STAFF REPORT: SEPTEMBER 11, 2024 MEETING

APPLICATION NUMBER: HDC2024-00424

ADDRESS: 15302 PIEDMONT

SCOPE: REPLACE WOOD WINDOWS WITH FIBERGLASS WINDOWS

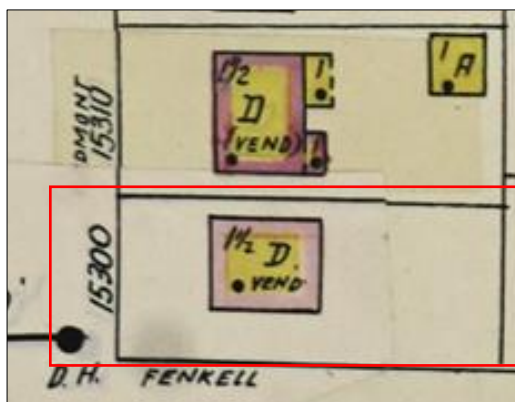
- The existing wood windows and exterior trim (i.e., brickmould) will be removed.
- Marvin Infinity fiberglass double-hung windows will be installed as well as new exterior coil trim. According to the window schedule, the two large front windows are to have grids between the glass in the upper sash only; remaining windows will be one-over-one. Color: Stone White.

- The front 8-over-12 cottage windows, diamond paned leaded glass window, and south side 6-over-6 double-hung window are character-defining features and the applicant has not provided information to support the windows are beyond repair. Therefore, a replacement product should not be considered at this time. Additionally, when windows are beyond repair, the Standards require that the new windows must match the old in design, dimension, and operation.

- The change of the two 8-over-12 cottage-style windows to 12-over-1 double-hung windows would alter features that characterize the property.
 - Grilles between the glass do not match the dimensionality of the existing true divided light windows.

- The wood brickmould offers a dimensionality, profile and finish that can not be replicated with coil stock.
- The stone white color is not appropriate for the house's minimally traditional English Revival design.

Staff therefore recommends that the Commission issue a Denial for the work as proposed, as it does not meet the Secretary of the Interior's Standards for Rehabilitation, specifically Standards 2, 5, and 6:

Vol. 25 Sanborn Map, 1950.

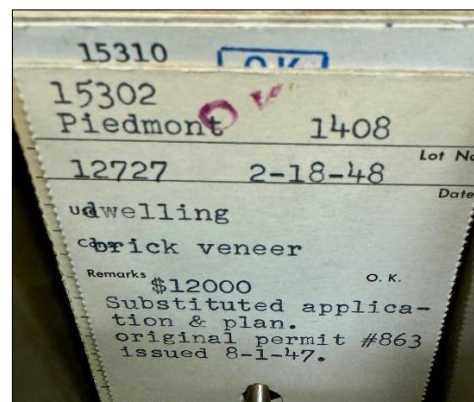
- The house was erected in 1948 and, according to the 1950 Sanborn map, did not include a rear porch or extension. Staff did not find a record of when the rear addition was erected. However, according to an October 2007 Google street view image, it was in place at time of district designation.
